SERVICE INFORMATION NO. SI D4-144

All DA 40 D airplanes equipped with Thielert TAE 125-01 engine

Update of TAE Repair Manual RM-02-01 Issue 4 Revision 7
ATA-Code: 72-10

Fig. 05.0.5

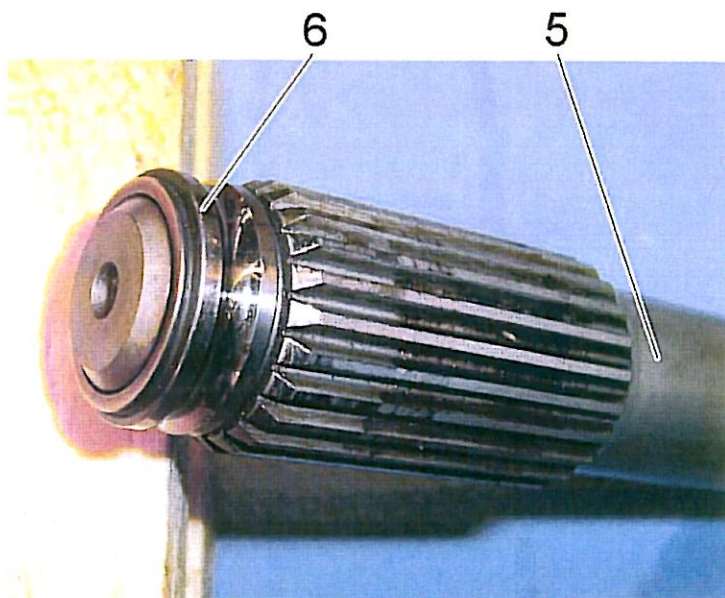
6. Remove the clutch shaft (item 5) and the clutch shaft bearing (item 6). Pay attention to cleanliness! Discard the clutch shaft (item 5) and the clutch shaft bearing (item 6) and replace them with new ones during re-assembly.
7. Fit the new clutch shaft bearing (item 6) to the clutch shaft (item 5). See Fig. 05.0.5.

■ **CAUTION:** Make sure that the bearing is fitted correctly to the clutch shaft.
